# TECHNICAL SERVICE BULLETIN

## 5 Door - Hard Top - Poor Sirius XM® Satellite Radio Reception And/Or Signal Loss - Built On Or Before 17-May-2022

**22-2096**

<b>Ford</b> 2021-2022 Bronco
---------------------------------

Figure 2

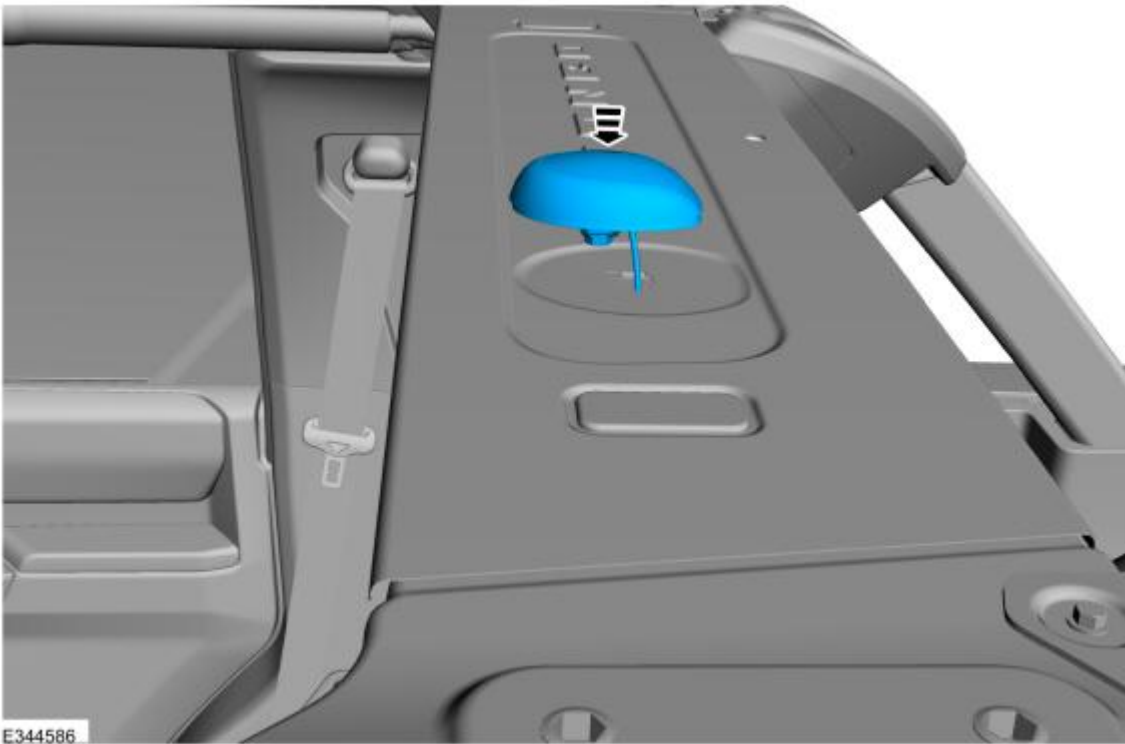
3. Inspect the position of the satellite radio/GPS antenna. Does the base of the antenna match the depression/outline in the sheet metal? (Figure 2)

(1). Yes - proceed to Step 4.

(2). No - this article does not apply. Refer to WSM, Section 415-00.

Figure 3

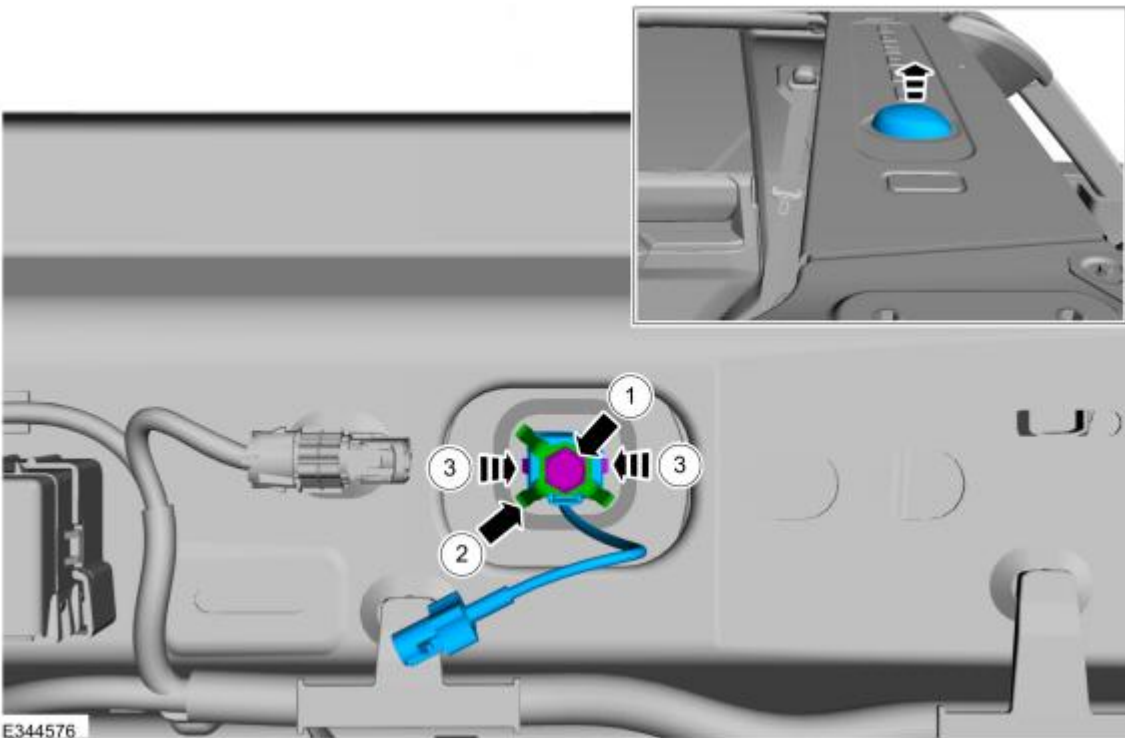
4. Remove the rear header trim panel. (Figure 3) Refer to WSM, Section 415-00, Satellite Radio/GPS Antenna > Removal and Installation > Step 1-15.

Figure 4

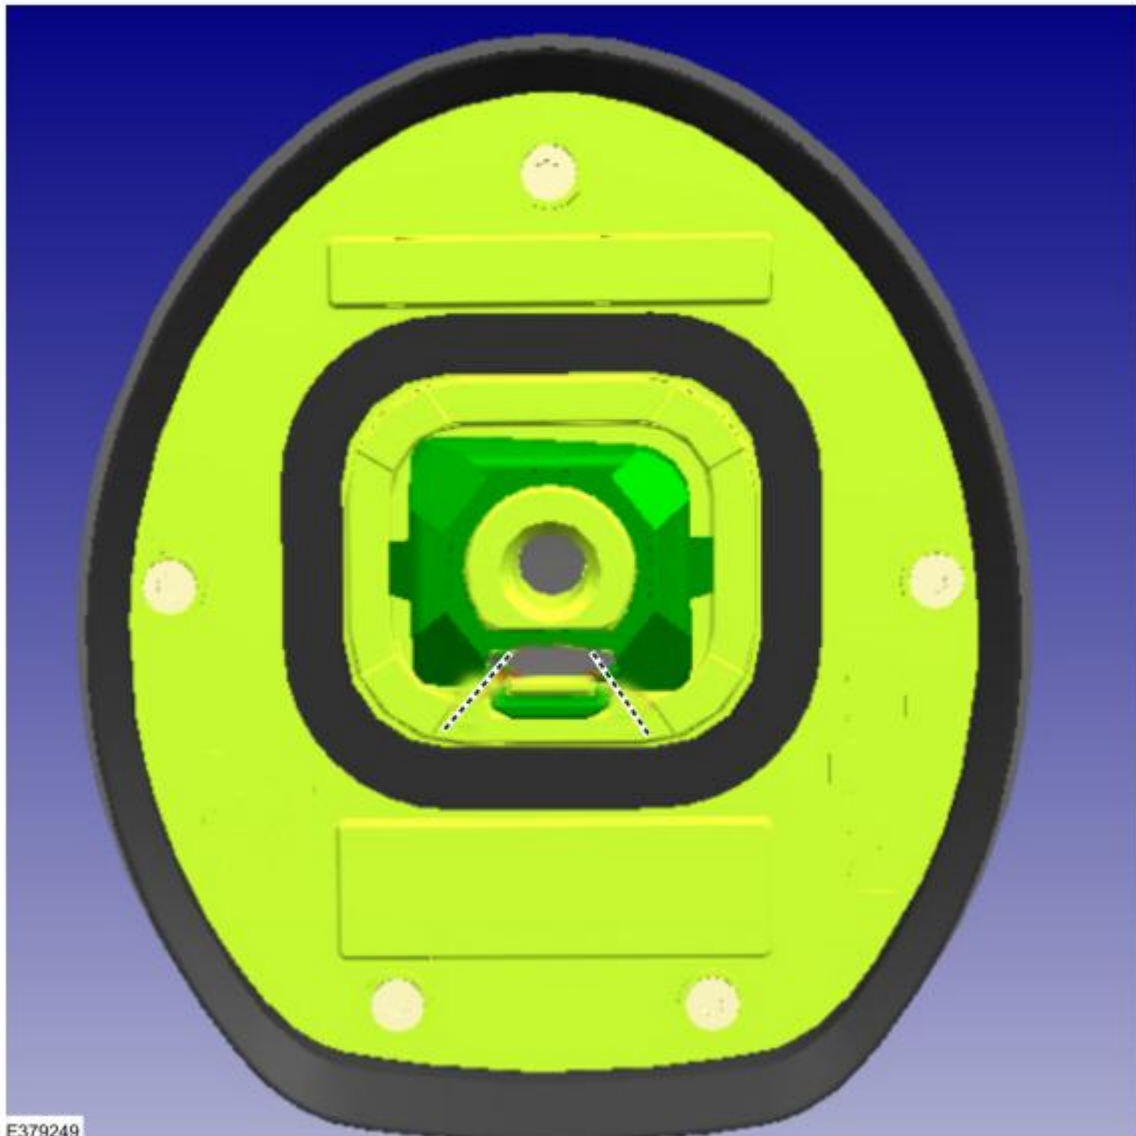
5. With the antenna removed from the vehicle, cut the plastic locator/orientation tab off the plastic antenna base. (Figures 4-5)

6. Rotate the antenna 180 degrees from the original position. Place the antenna back on the vehicle with the flatter side facing toward the front of the vehicle. The base of the antenna should not match the depression/outline in the sheet metal.
7. Reinstall the antenna metal clip and 10 mm hex bolt. Tighten to 8.0 Nm (6.0 lb-ft).
8. To install, reverse the removal procedure.
